ADDENDUM 5

DATE: June 16, 2016

PROJECT NAME: NAVAJO TRIBAL UTILITY AUTHORITY WASTEWATER TREATMENT PLANT UPGRADES

PROJECT NO. 115111

CIVIL
CELL 2 EFFLUENT STA 10+00.00 TO STA 11+45.68

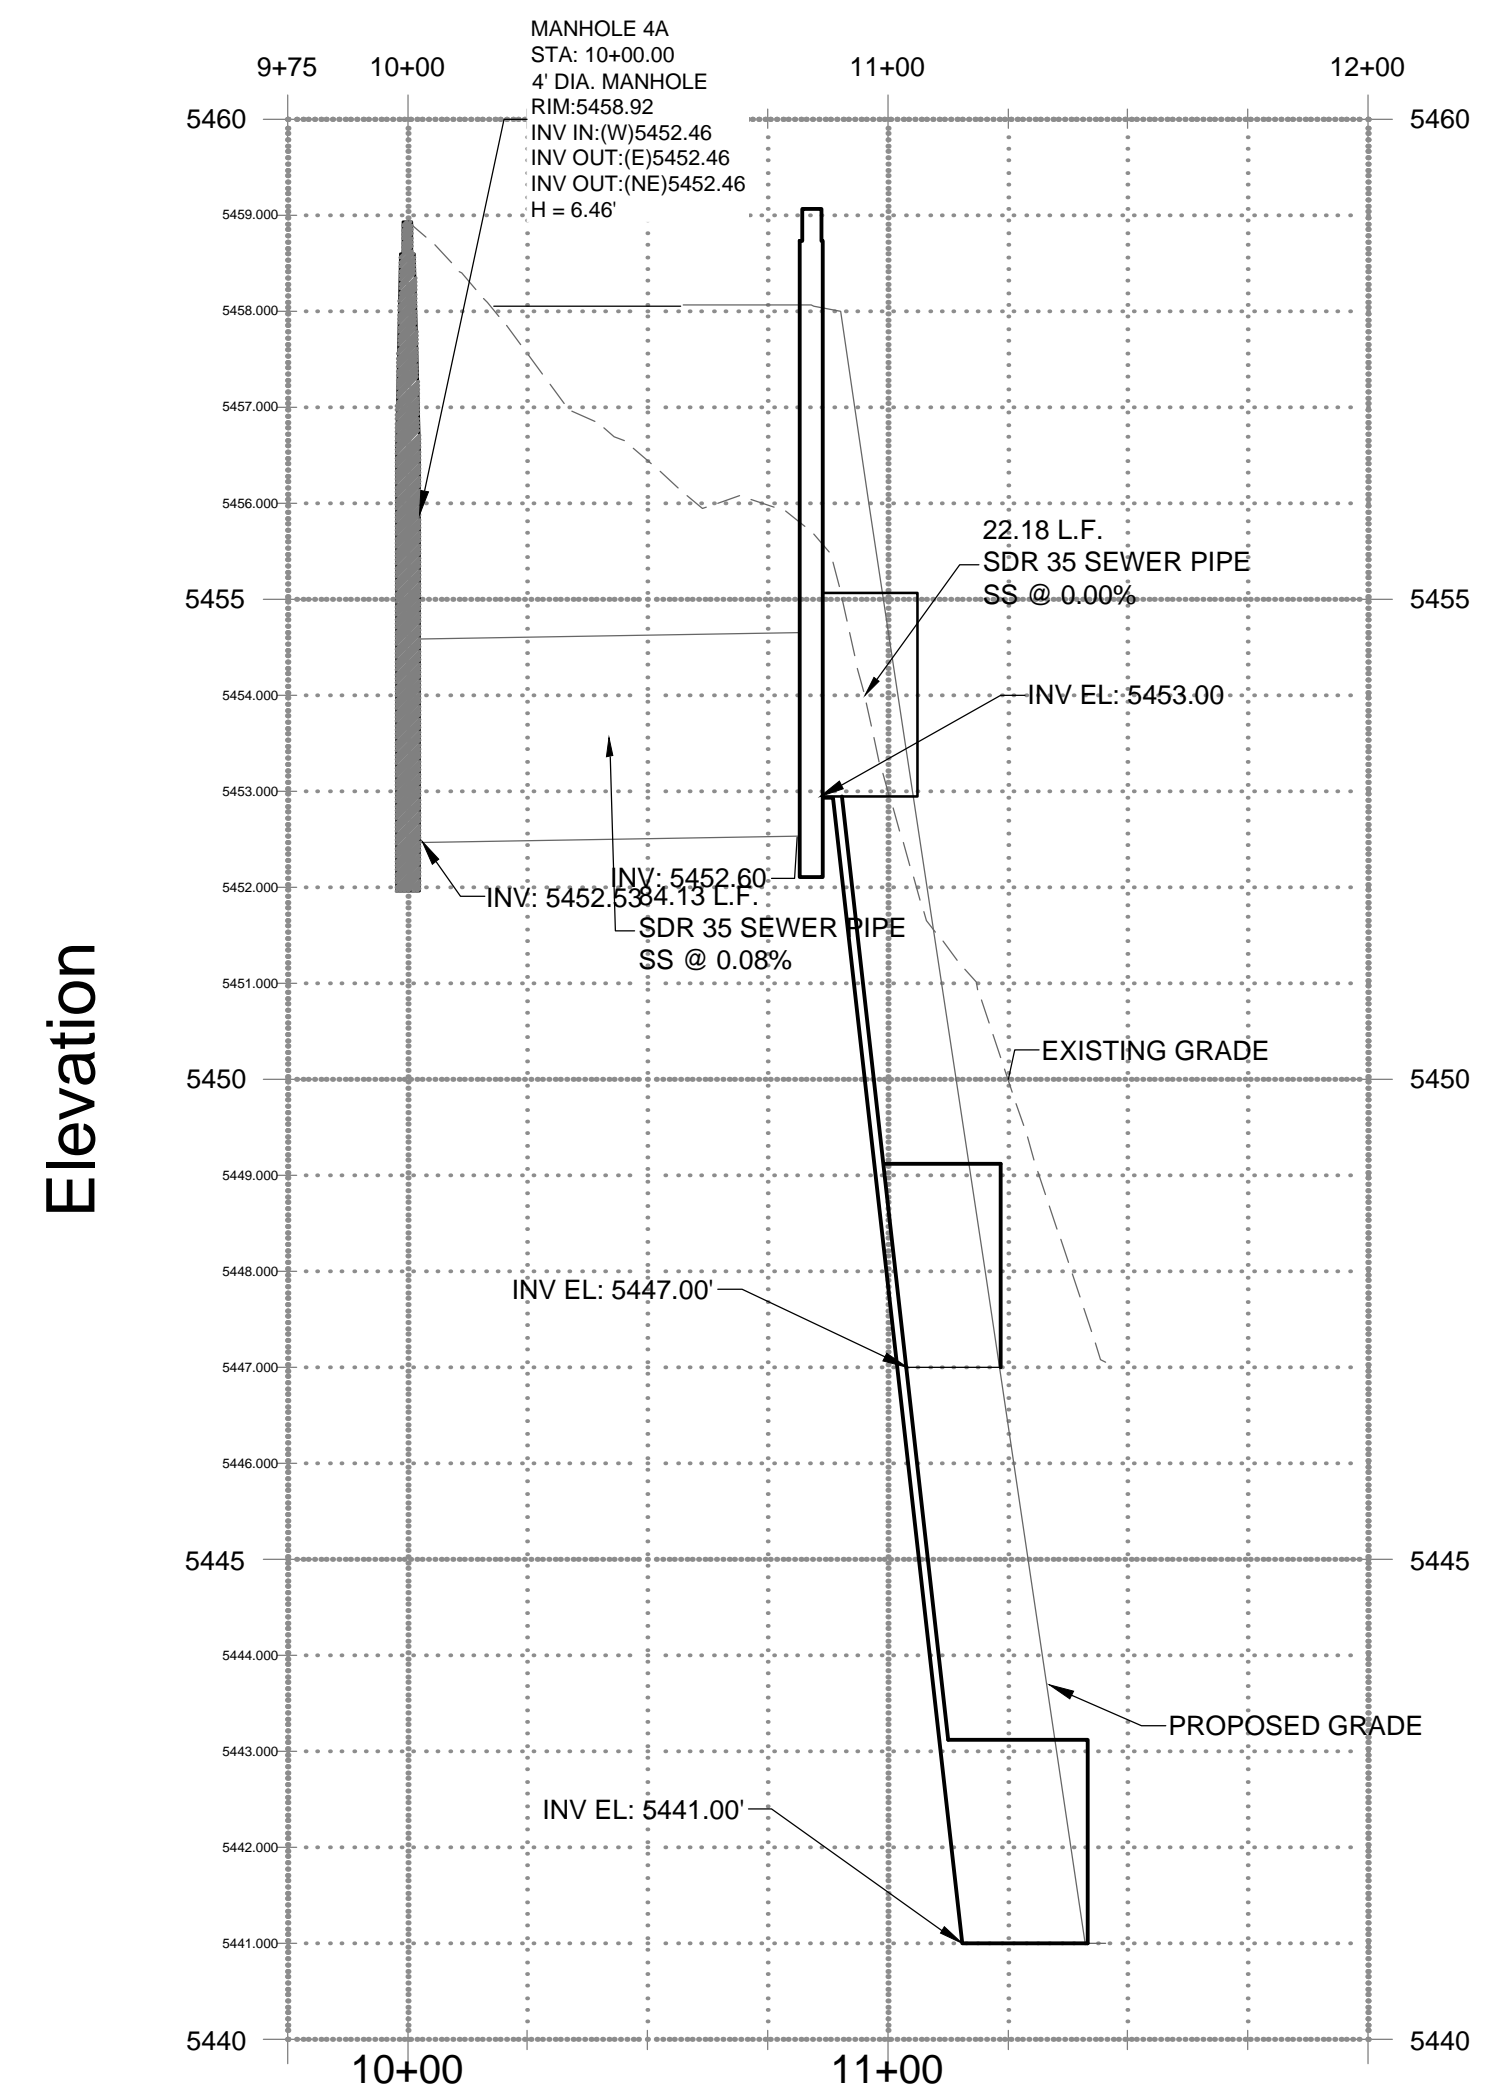
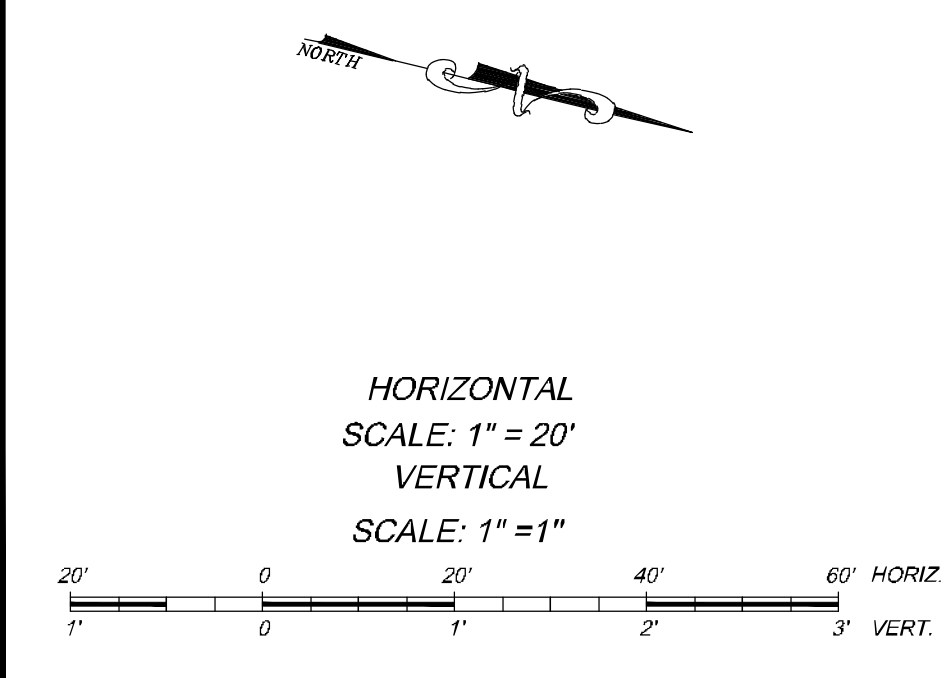
6. **Question:** Regarding Supplemental Specifications section 31 55 00 – Earth Retention, where does this apply? The only structure that we see that may need something is the new junction box at Chinle between dells 2 and 4. If cell 4 has water in it that will be a problem to dig that deep (20' below existing ground). Soil nails don't look like the right application for this

1. **VOLUME 2.1 CHINLE WWTP:** REMOVE sheet 16 and 17 dated April 2016 and REPLACE with the attached sheet 16 and 17 dated June 2016.

- BUILD NOTES**
- 24 INCH PVC SAS; FURNISH AND INSTALL 24-INCH SDR 35 PER STANDARD SPEC 615, INCLUDES TRENCHING, BACKFILL AND COMPACTION PER STANDARD 601; COMPLETE AND IN PLACE.
 - FURNISH AND INSTALL JUNCTION BOX, PER DETAILS. SEE SHEET 16.
 - PLUG SAS.

Response: Please see the modifications to the bid documents below. These modifications should eliminate the need for earthwork retention for junction box 7.
